**ADDENDUM #001
ITB 2408-2024
Hartsfield Cafeteria Food Service Equipment**

Solicitation: ITB 2408-2024 Hartsfield Cafeteria Food Service Equipment

Leon County Schools
Frank Hartsfield Elementary School
Cafeteria Replacement Project
 1414 Chowkeebin Nene,
 Tallahassee, FL 32301

Change No. 1:

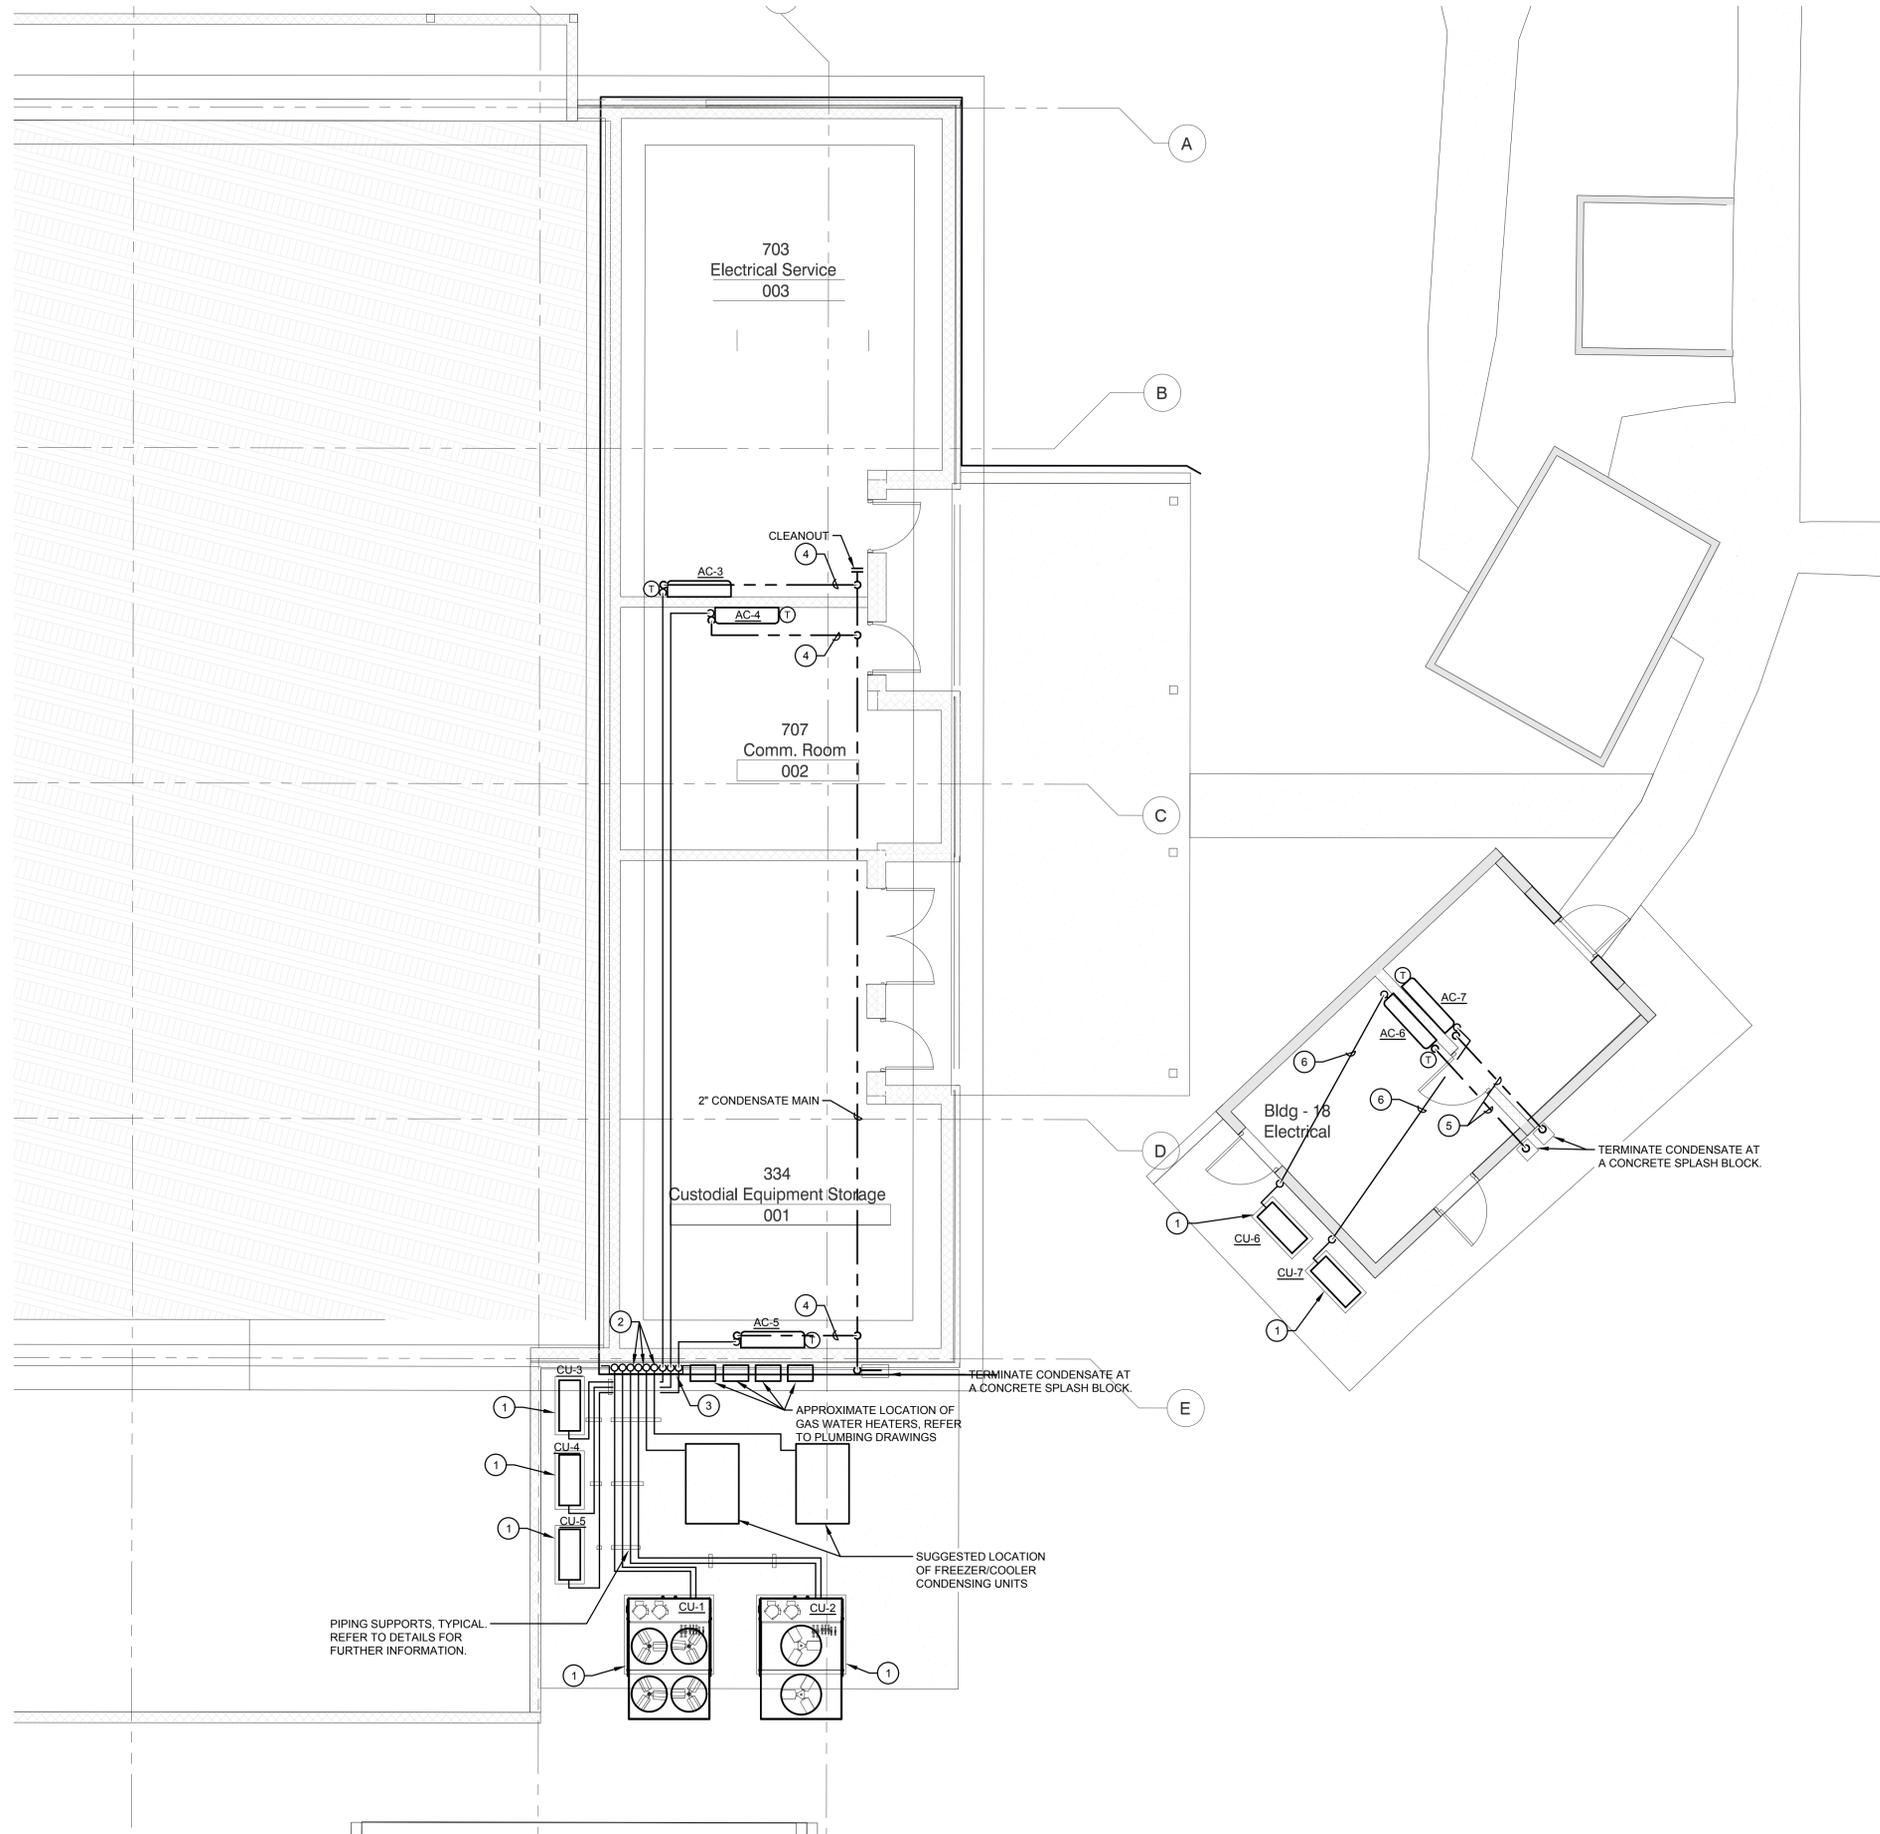
2.7 Pricing: The District is requesting a total base bid price using Attachment I, Price Sheet. The Contractor shall include in their unit price all labor, materials, equipment, tools, transportation, storage, delivery, installation, bidding costs, and any other facilities and services required for the proper execution and completion of the work as specified herein. The price is not subject to any material or labor escalation for the duration of the Project.
